131 13TH AVE E

EARLY DESIGN GUIDANCE RESPONSES | NEIGHBORHOOD CONTEXT / MASSING OPTIONS

EARLY DESIGN GUIDANCE 2
09/07/2022 #3038084-EG

i. Front setbacks and Massing

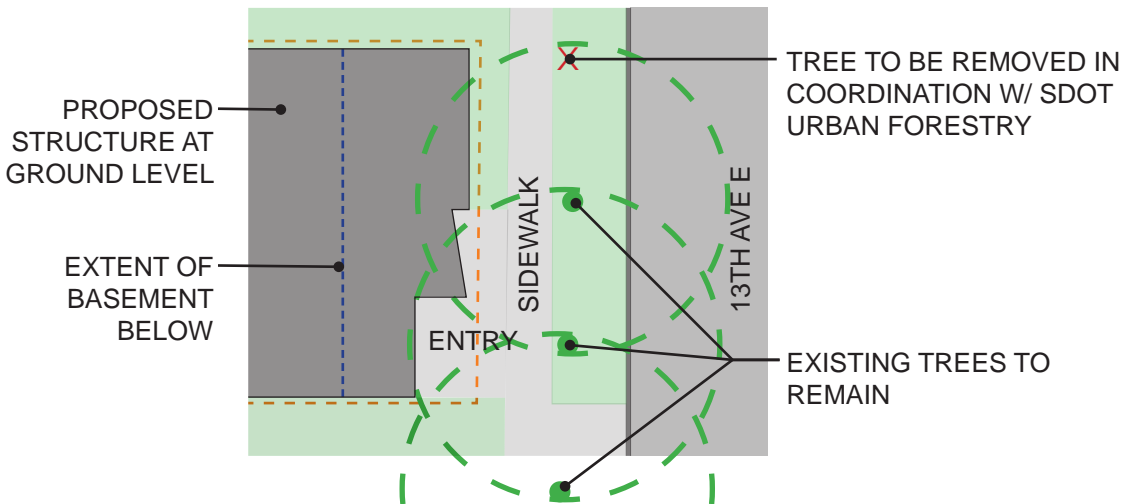
The board noted the exceptional trees in the public right of way and provided the following guidance:

- 1. Further examine appropriate setbacks for both the ground level and basement level with the goal of reducing encroachment into the root zones.
- 2. Provide site plans with adjacent building footprints and tree root zones.
- 3. The board discussed studying a 3-4 story expression along the street to better bring the scale down, but no specific guidance was provided.

The site plans for the various schemes have been updated to show the outline of adjacent buildings and assumed root zone of the adjacent street trees. The preferred design sets the basement significantly further back from the sidewalk to reduce the impact to the roots of the existing trees in the ROW. The southern portion of the ground floor is also set back, in order to minimize the impact to the existing tree roots. In consultation with SDOT urban forestry and various municipal entities, the northernmost tree will be removed to accommodate the required utilities and updated services for the area, while maintaining the rest of the trees at the site frontage.

Due to the narrow frontage of the site, a large setback at 3-4 stories results in a facade that is too fractured and busy. Instead the provided character sketch shows how a more refined modulation and use of material and horizontal secondary elements can help define datums to the existing context, while the overall structure relates to future development.

iii. Entry

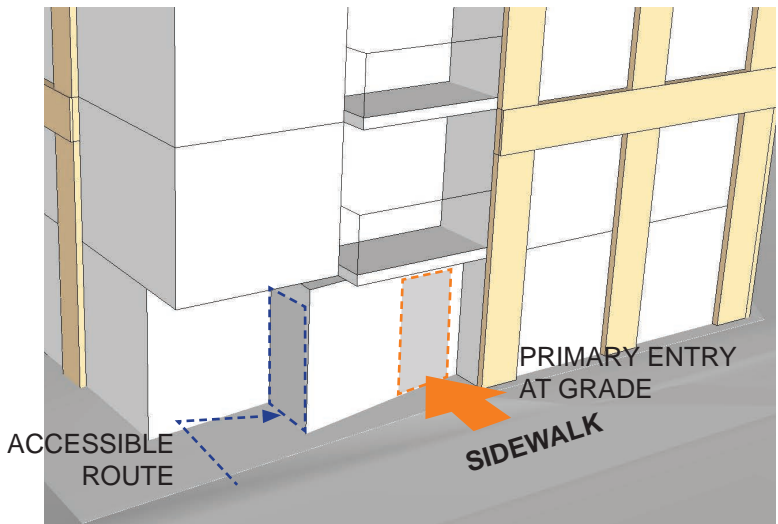
The Board appreciated the precedent images provided in the packet, however, noted the precedents depicted stoop entry conditions while the proposal had a sunken entry. The Board gave the following guidance to improve the legibility of the entry.

- 1. Provide more clarity on how the entry will incorporate canopies and other architectural elements to denote the entry.
- 2. The Board supported the lantern idea, which had potential to highlight the entry and adjacent amenity, however, observed this concept only happens in the Option C and not the preferred option B. As such, the Board would like to see how the arrangement of uses surrounding the entry can be refined to further enhance the entry sequence, similar to option C.
- 3. The Board also discussed the secondary entry at the alley, commenting that this entry is the closest connection to bike routes and the light rail, and should be further enhanced. The Board acknowledged the challenge of balancing service uses along the alley with the secondary entry, but would like to see more information on this item at the next meeting.

The primary entry along 13th Ave has been adjusted so that the front door is at grade with the adjacent sidewalk, with the grade transition occurring interior to the space. This strengthens the project's engagement of the pedestrian realm. A corner "lantern" expression above the lobby and the use of balconies directly above the entry act as way finding elements, accentuating both the ground level entry and the common amenity space at L8 above. The recessed modulation on the alley facade mirrors the design language of the street-facing facade, with the secondary entry within the recessed portion of the facade, further defined by balconies above.

REVISIONS TO THE ENTRY SEQUENCE LOCATE THE PRIMARY ENTRY AT GRADE, OMITTING THE "SUNKEN" ENTRY COURT FROM PREVIOUS OPTIONS.
